Fargo to St. Cloud 345 kV Transmission Line Project

PUBLIC COMMENT FORM

Fargo to St. Cloud 345 kV Transmission Line Project
PUC Docket No. E002, ET2/TL-09-1056

Map For: Mark Walsh

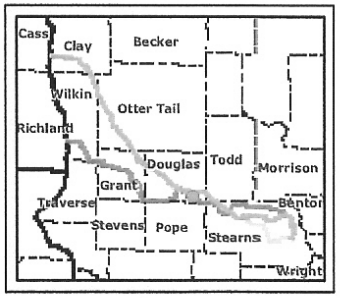
Also, please note that we have a 3 MW community wind project underway that will need site locations for the wind turbines in Sections 13, 23, 24, 25, and 26 of Hudson township.. A metreological tower has been installed and National Wind Assessment is doing a wind study over a 6 month period, starting October of 2009, to determine the best locations for the installation of the wind turbines.

- Move line from Walsh Dr SE to one mile north between section 12/13 of Hudson and section 18 19/19 and 17/20 of Orange.
- Pivot irrigator on SW 1/4 / SW 1/4 of section 13 Hudson Township. Irrigator planned for organic farm on NE 1/4 of section 13 of Hudson Township
